ALTERNATE BARRIER DETAILS - CONNECTION BEFORE LOAD TRANSFER

MARK	DATE	DESCRIPTIONS	BY	CH'D	CCO#
0	04/05/10	BARRIER MODIFICATIONS	GB	MN	44

SAN FRANCISCO OAKLAND BAY BRIDGE
EAST SPAN SEISMIC SAFETY PROJECT
SELF-ANCHORED SUSPENSION BRIDGE
(SUPERSTRUCTURE & TOWER)

BARRIER DETAILS NO. 2B

PLAN-STEEL BARRIER Type 732 Modified for (W2) (E5)

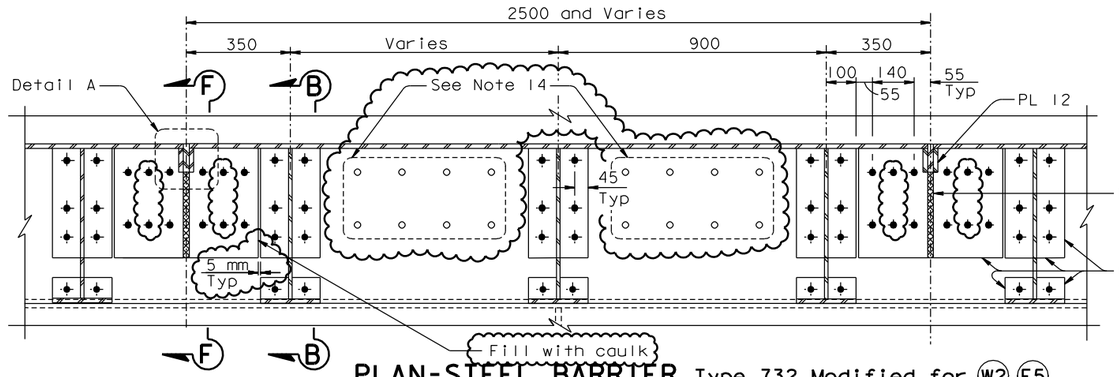
FOR LIFTS 1 THROUGH 6: DECK DRILLED FOR DRAINAGE PLATES (See Note 13)

PLAN-STEEL BARRIER Type 732 Modified for (W2) (E5)

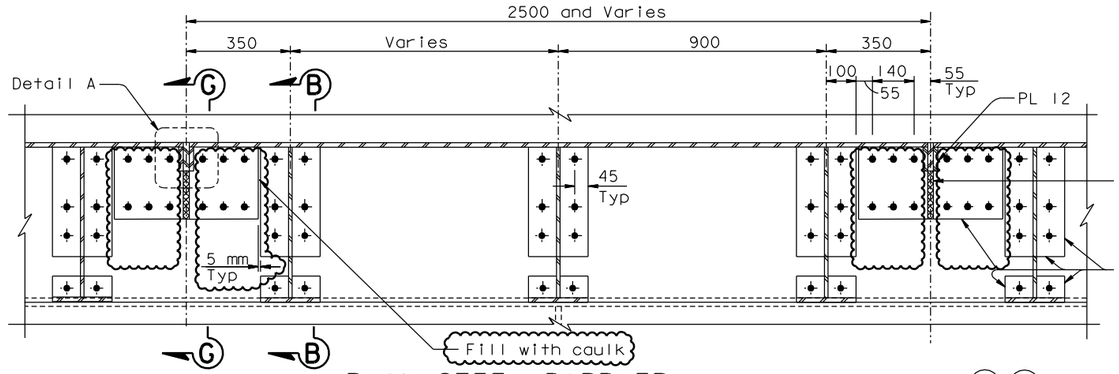
FOR LIFTS 7 THROUGH 14: DECK NOT DRILLED FOR DRAINAGE PLATES (See Note 13)

13. For Section B-B and Details not shown for Lines W2/E5, see "Barrier Details No. 2".
14. Drainage PL 25x319x698 not required. Fill all drilled holes with M22 HS bolts.
